Groundwater Transfer Review Summary Form

Transfer/PA # T- 14115

Application: T-14115

Applicant Name: Orchard Heights Water Association

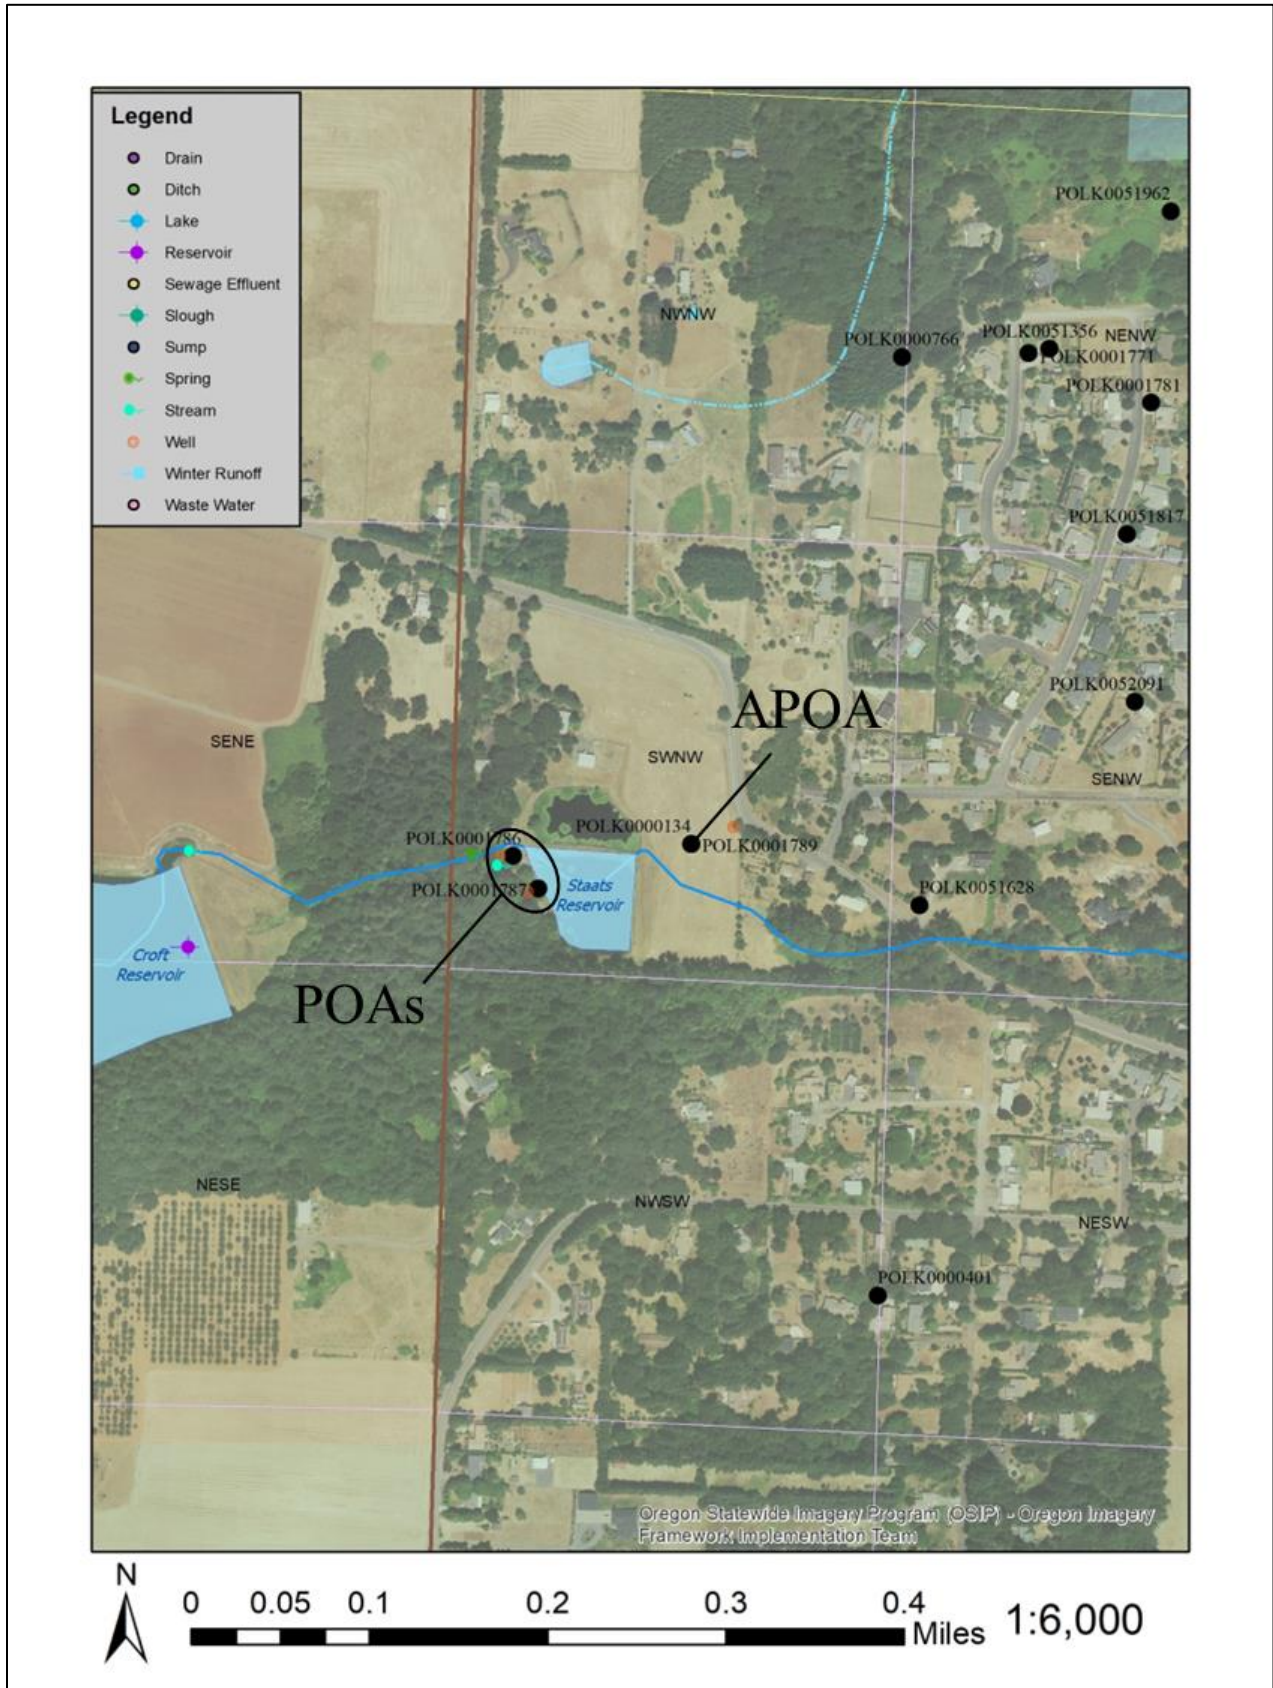
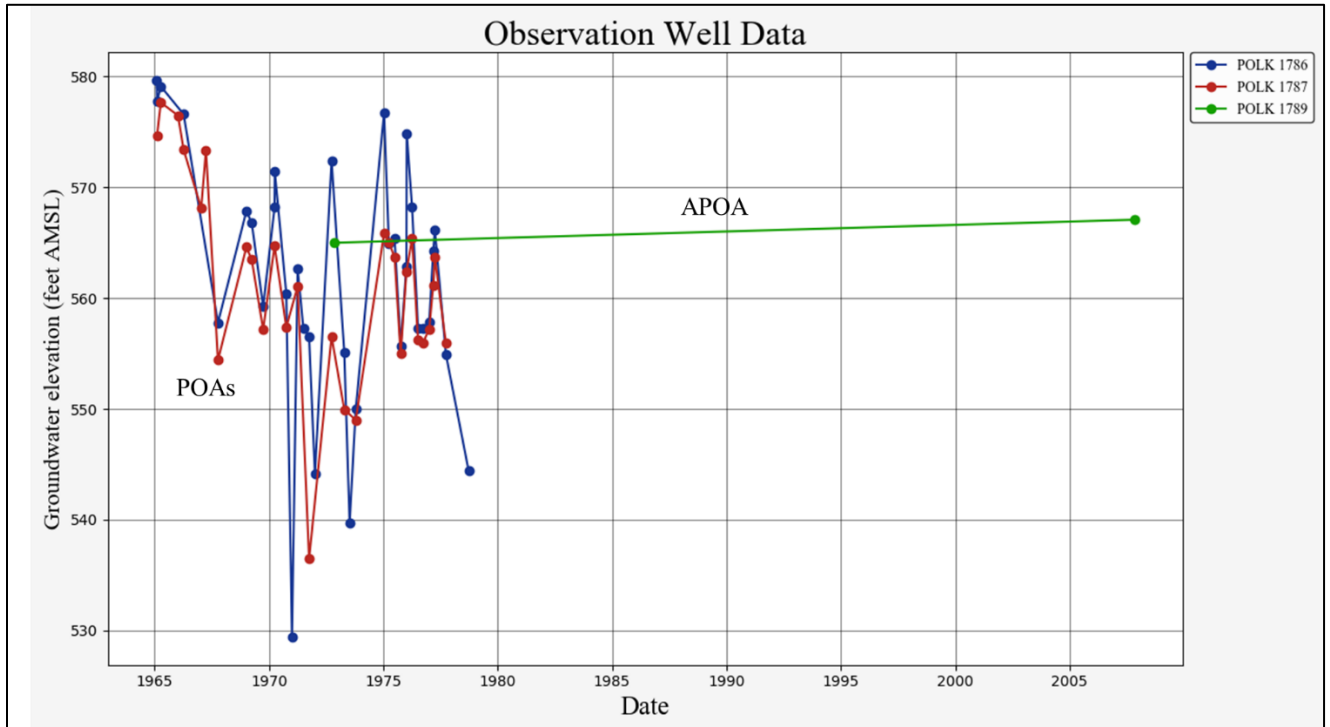
Yes No Comments: The proposed APOA is not significantly closer to any surface water source than either of the currently authorized POA wells. It is also questionable whether the CRB aquifer is hydraulically connected to surface water in the immediate vicinity, based upon the difference between the elevations of surface water and groundwater in these CRB wells (see attached hydrograph and cross-section).

Available water level data indicate the APOA well is likely to produce from the same water-bearing zones as the two authorized POA wells.
